HISTORIC AND DESIGN REVIEW COMPLIANCE AND TECHNICAL ADVISORY BOARD

HDRC CASE NO: 2024-073
ADDRESS: 3502 BROADWAY
LEGAL DESCRIPTION: NCB 6138 BLK LOT 45- 46
ZONING: C-2, RIO-1
CITY COUNCIL DIST.: 2
DISTRICT: Tobin Hill Historic District
APPLICANT: Louis Talamantez/LT Electric, LLC
OWNER: Carim Khanmohamed/Smoke Shop
TYPE OF WORK: Signage and installation of window film
APPLICATION RECEIVED: January 19, 2024
60-DAY REVIEW: March 19, 2024
CASE MANAGER: Jessica Anderson
REQUEST:

1. Install signage, including an internally illuminated sign mounted on a 12'x4' backing and window vinyl featuring the business logo in four locations.
2. Install under-eave lighting along the primary elevation of the building.

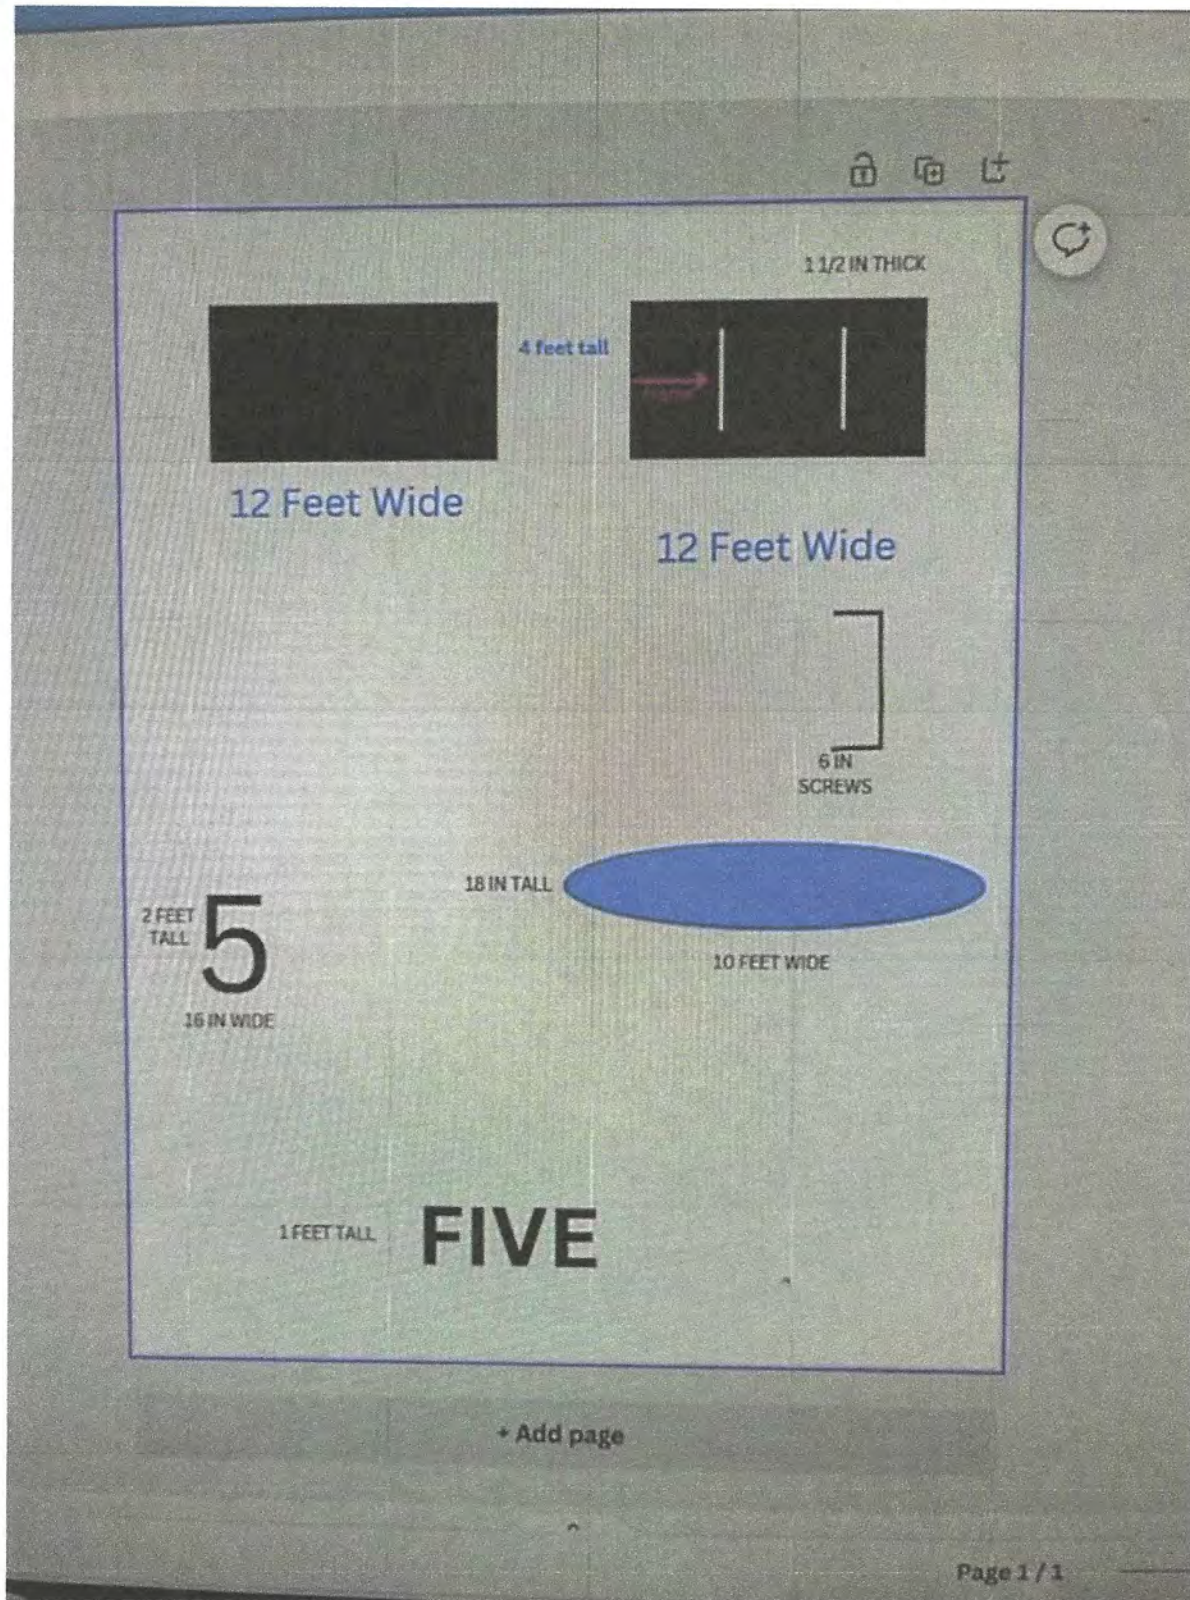
- b. **SIGNAGE:** The applicant requests approval to install signage, including an internally illuminated sign mounted on a 12'x4' backing and window vinyl featuring the business logo in four locations. UDC 35.678 says applicants may apply for up to three (3) signs total. Total signage for all applicants shall not exceed fifty (50) square feet unless additional signs and/or additional total footage is approved. Additional square footage may be approved provided that the additional signage is in conformity with, and does not interfere with, the

pedestrian experience on the Riverwalk. The additional square footage shall be based upon the size and scope of the site. The parapet sign is 48 square feet including the backing. Staff was unable to determine the dimensions for window signage found on site, but the total square footage of the logos on the window vinyl exceeds 2 square feet. Staff finds the signage does not conform to UDC and should be reduced to three signs that do not exceed 50 square feet in total.

- c. **WINDOW VINYL:** The applicant requests approval to install full window vinyls across the elevation. All graphic elements shall reinforce the architectural integrity of any building. Signs shall not disfigure, damage, mar, alter, or conceal architectural features or details and shall be limited to sizes that are in scale with the architecture and the streetscape. Emblems and symbols of identification used as principal structural or architectural design elements on a facade shall not be included in the total allowable signage per facade per structure when approved. Review shall be guided by the building's proportion and scale when such elements are incorporated. Staff finds the window vinyl inappropriate and that overall window coverage should be reduced.

- d. **LIGHTING:** The applicant requests installation of under-eave lighting along the primary elevation of the building. UDC 35-673 says all security lighting shall be shielded so that the light sources are not visible from a public way, and that light temperature and color shall be between 2500°K and 3500°K with a color rendition index (CRI) of eighty (80) or higher, respectively. Levels shall be determined by product specifications. Staff finds the under-eave lighting does not conform to UDC.

- i. That the applicant reduces signage to no more than three signs that are equal to or less than 50 square feet in total, as noted in finding b. This includes reduction of window clings to conform with signage standards, as noted in finding c.
- ii. That the applicant proposes under-eave lighting that conforms to UDC 35.673, namely lighting that is shielded to reduce glare and with a lighting temperature that meets RIO standards, as noted in finding d.
